SOLICITATION AMENDMENT

Title - Sujet Parking Lot Repair JAG Bldg PEI	
Solicitation No. - N° de l'invitation ED001-170593/A	Amendment No. - N° modif. 002
Client Reference No. - N° de référence du client R.074056.001	Date 2016-07-06
GETS Reference No. - N° de référence de SEAG PW-\$PWC-023-3902	
File No. - N° de dossier PEI-6-39030 (023)	CCC No./N° CCC - FMS No./N° VME
Solicitation Closes - L'invitation prend fin at - à 02:00 PM on - le 2016-07-12	
Time Zone Fuseau horaire Atlantic Daylight Saving Time ADT	
F.O.B. - F.A.B. Plant-Usine: <input type="checkbox"/> Destination: <input checked="" type="checkbox"/> Other-Autre: <input type="checkbox"/>	
Address Enquiries to: - Adresser toutes questions à: Ellis-Herring, Alison	Buyer Id - Id de l'acheteur pwc023
Telephone No. - N° de téléphone (506) 636-3908 ()	FAX No. - N° de FAX (506) 636-4376
Destination - of Goods, Services, and Construction: Destination - des biens, services et construction:

Addenda numéro 2.

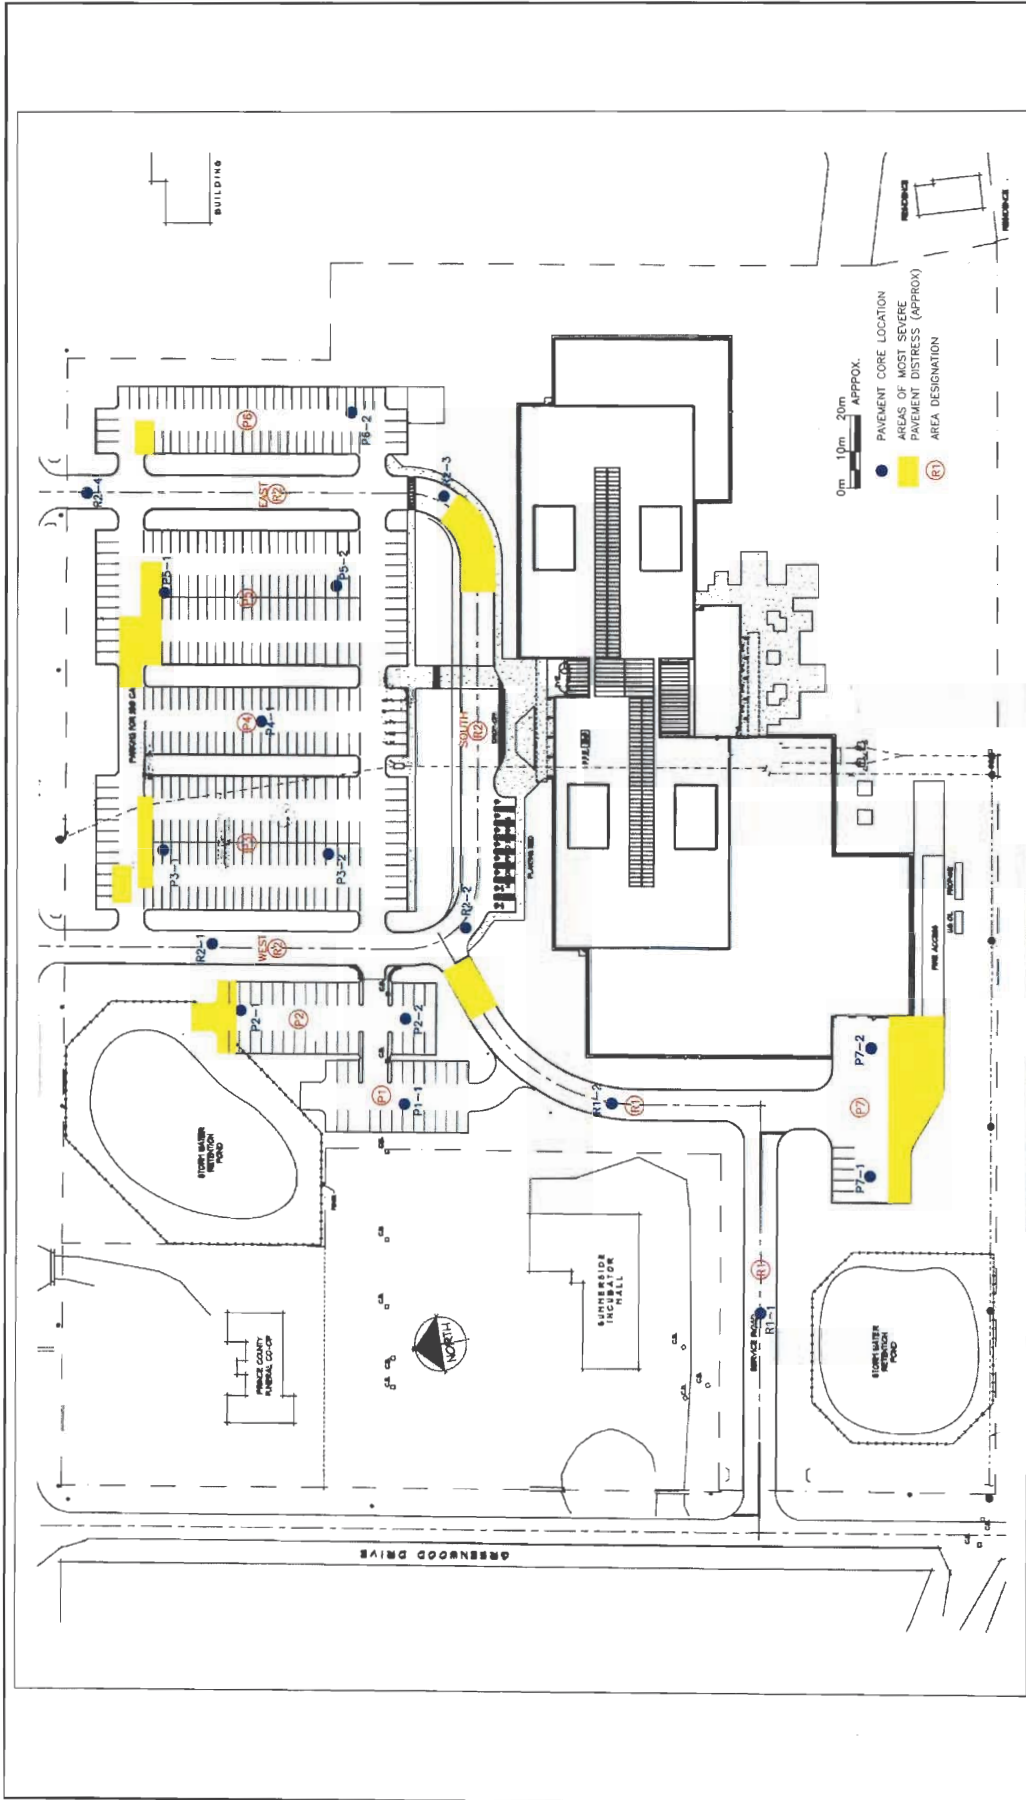
I do not see an appendix A in the documents and as it is vital to know the existing thickness, Can you please provide any information on this that you have. We will need to know the thickness to calculate the price per M2 for the removal of asphalt.

A2. See attached, "Table 1 – Pavement Coring Summary" and Dwg No. 1 titled "Pavement Condition Assessment".
